217 WEST 57TH STREET
NEW YORK, NY

VOLUME 2 OF 2 - ZONING

Summary of Comments on P:\Projects\1216-00\BIM\Revit \Families\TITLEBLOCKS\EXTELL Proposal_atwalj.pdf

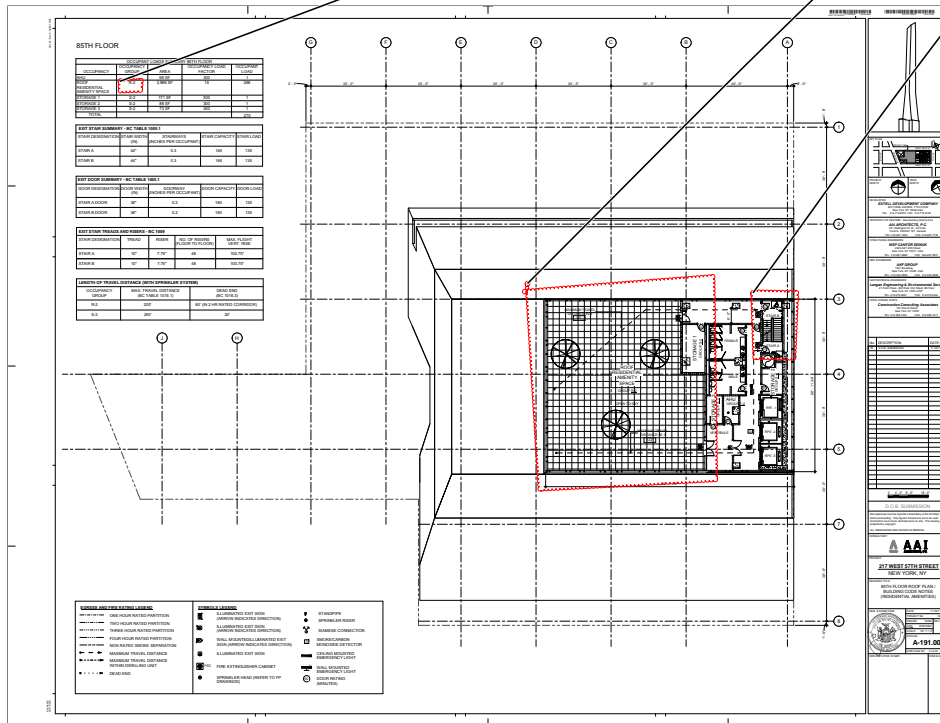
Author: dtitus Subject: Polygon Date: 1/4/2013 10:08:37 AM
A-occupancy

BC 403.11.1 Emergency power systems for *assembly occupancy*

- 04-16-13
1. Exit signs and means of egress illumination required by chapter 10.2.
3. emergency voice communications systems; and
4. Electrically powered fire pumps, unless electrical power to the motor is taken ahead of the main from the street side of the service switch.

Author: dtitus Subject: Polygon Date: 1/2/2013 11:59:00 AM
All interior stairs must lead to the roof as per BC 1009.12

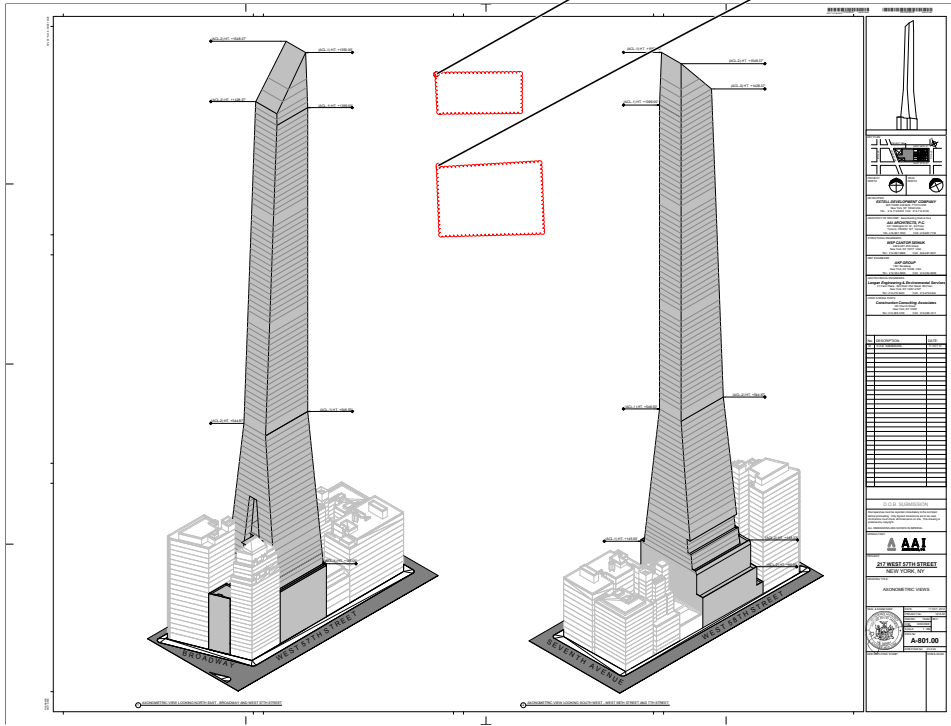
Provide all schedules windows, doors (indicate FPSC on all fire rated doors) etc.

Provide structural peer review report as per BC 1627.

Provide building elements, exterior walls of non-combustible construction with fire-resistance ratings for Type I-B construction (BC 602.1, BC 602.2).

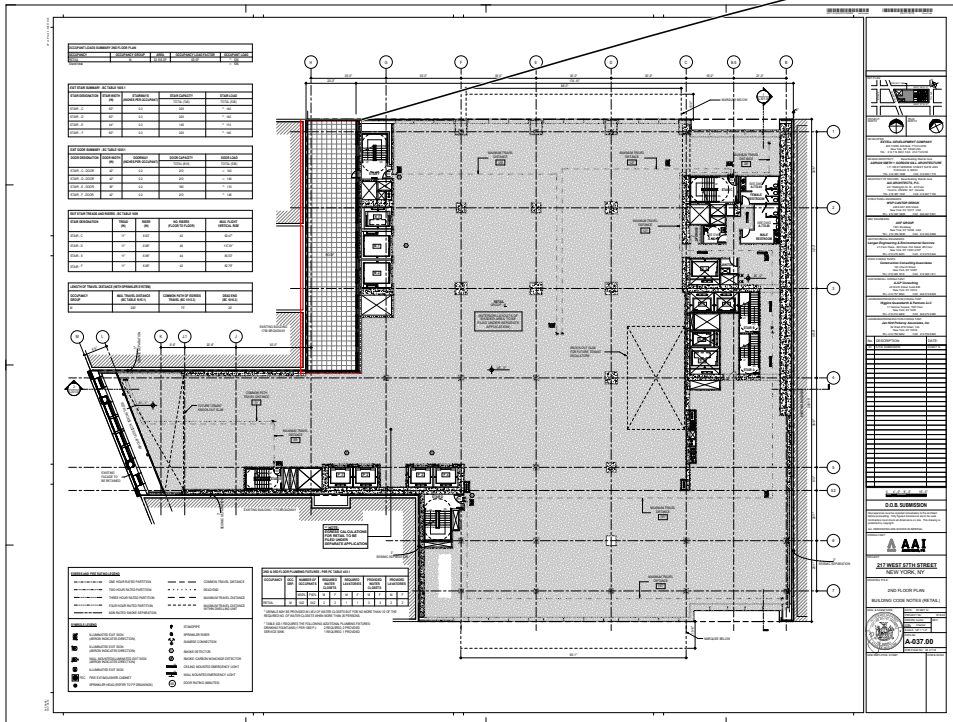
Provide net area of space and number of persons to be accommodated based on (15) sq. ft./person as per table 1004.1.2 BC

Provide the required number of exits per space, per maximum occupant load as per Table 1014.1.

Provide exit lighting and directional signs (lighting) & (egress) as per BC 1006, BC 1011, BC 1026 (both EG and Construction plans)

roof no occ. 11-18-14

NO occ. 11-18-14

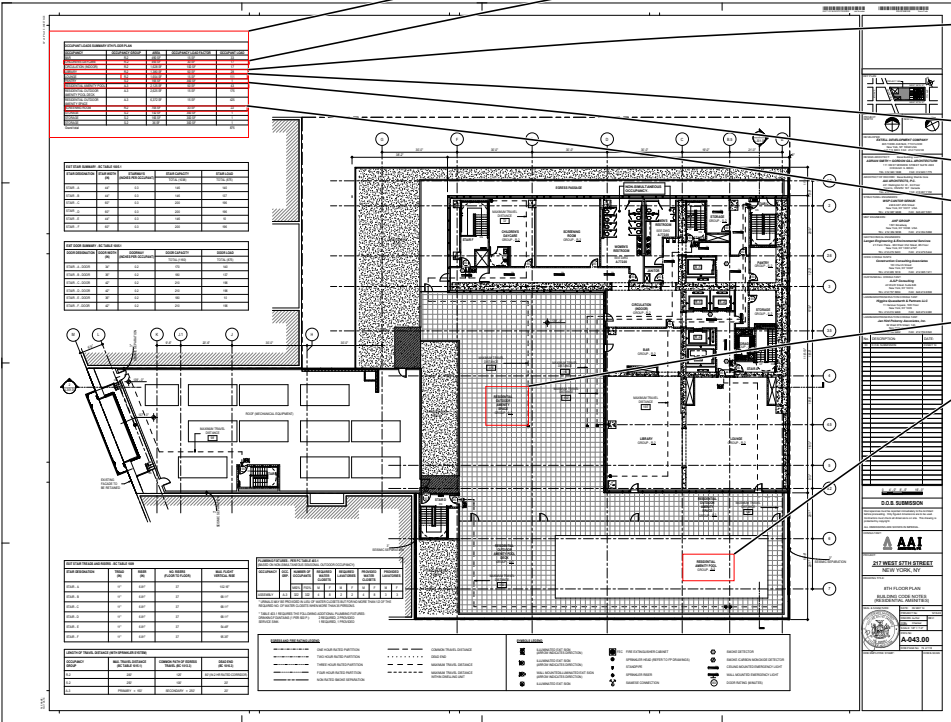
Author: dtitus Subject: Rectangle Date: 10/7/2014 8:25:25 AM
TABLE 403.1 Provide table for plumbing fixtures to comply with table. 403.1. Provide calculations within each space, 11-18-14

Provide the required number of exits per space, per maximum occupant load as per Table 1014.1. 01-12-15

Provide the required number of exits per space, per maximum occupant load as per Table 1014.1. 11-18-14

Author: dtitus Subject: Rectangle Date: 10/7/2014 8:03:54 AM
A-2 occ. 01-12-15

Author: dtitus Subject: Rectangle Date: 10/7/2014 8:03:24 AM
R-2 occ. 11-18-14

Provide the required number of exits per space, per maximum occupant load as per Table 1014.1. 01-12-15

Author: dtitus Subject: Rectangle Date: 10/7/2014 8:28:30 AM
Provide exit signs as per BC 1006, BC 1011, BC 1026 (both EG and Construction plans) 11-18-14

Author: dtitus Subject: Rectangle Date: 10/7/2014 8:45:47 AM
Propose swimming pool not located within a building does not meet the requirements of ZR 12-10 accessory use (5), (ii).

11-18-14 pool below roof line.
see A021 for compliance

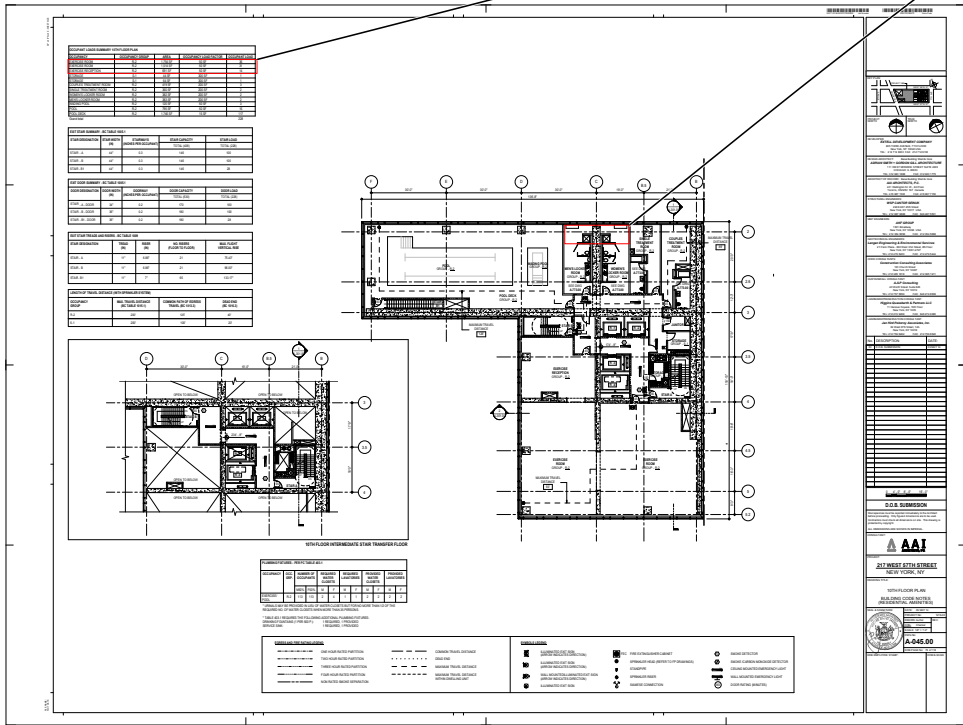
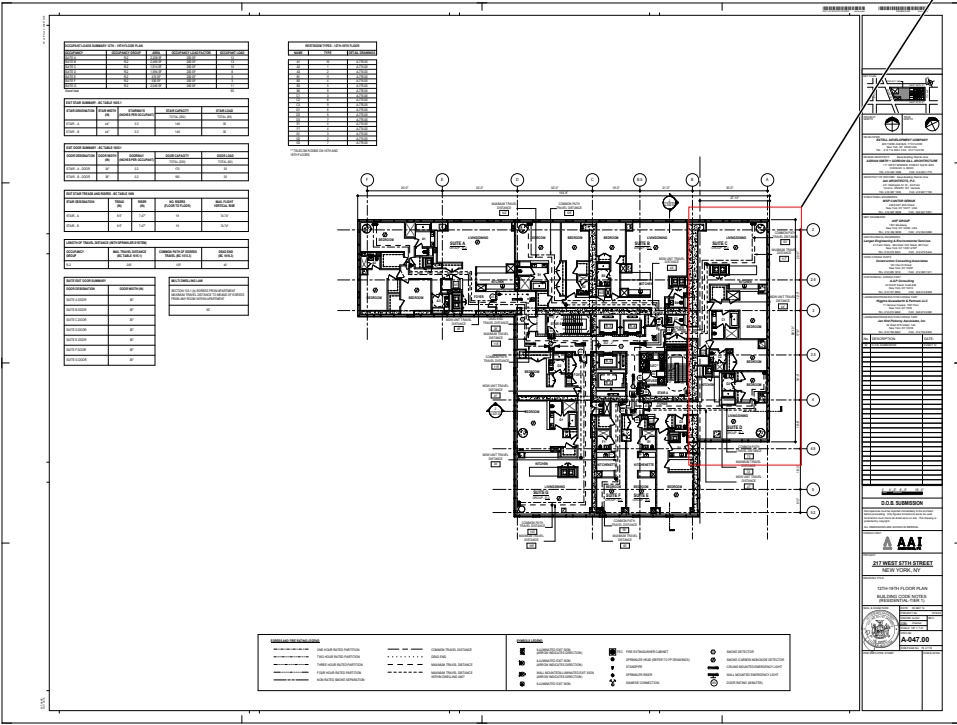
kitchen to be verified????

Author: dtitus Subject: Rectangle Date: 10/7/2014 9:10:59 AM
one space A- occupancy.

Author: dtitus Subject: Rectangle Date: 10/7/2014 9:12:42 AM
owers not permitted if acc. to R occupancy.

BC 1101.1, 1101.2, and
ICC/ANSI A117.1-2003 Verify compliance with accessibility as per BC 1101
1. Doors & maneuvering clearances-1107.2.1
2. Residential bathrooms - 1107/ Appendix P
3. Residential kitchens - 1107

5. Walk-in closets

6. Access to W/D within units (Where washing machines or clothes dryers are provided within the dwelling or sleeping unit, such equipment shall comply with Section 611 (Washing Machines and Clothes Dryers) of ICC A117.1 and shall be front loading. Laundry equipment in accessible common-use areas as required in Section 1107.3 shall comply with Section E105.3. (TYP ALL R-2 Floors)

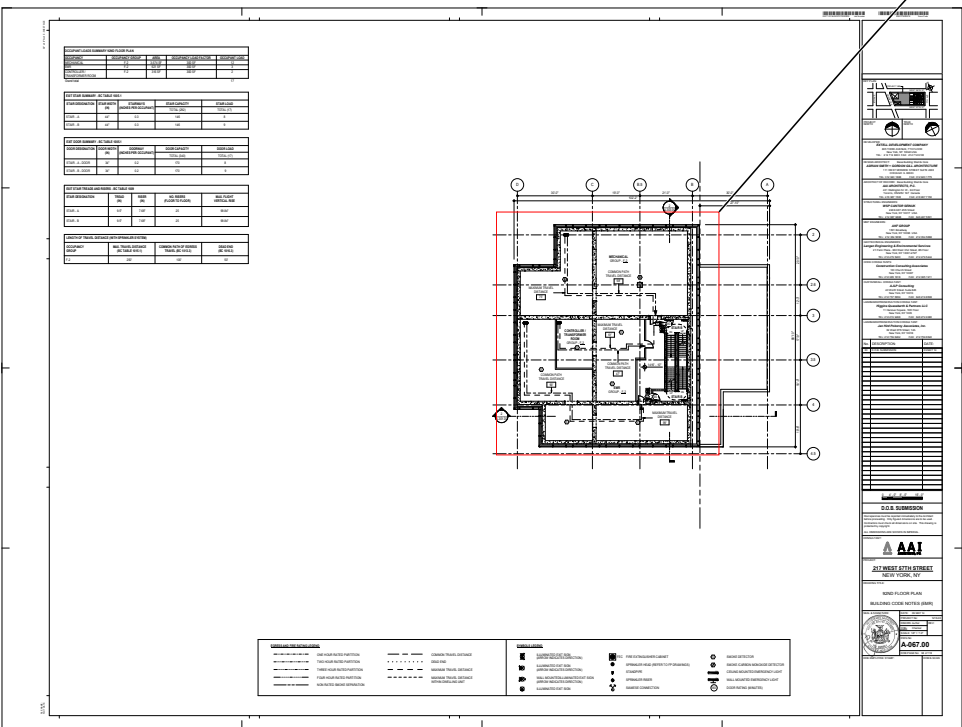
Author: dtitus Subject: Rectangle Date: 10/7/2014 9:21:38 AM
Please clarify, does the stair open to the roof top?

open to the roof 11-26-14
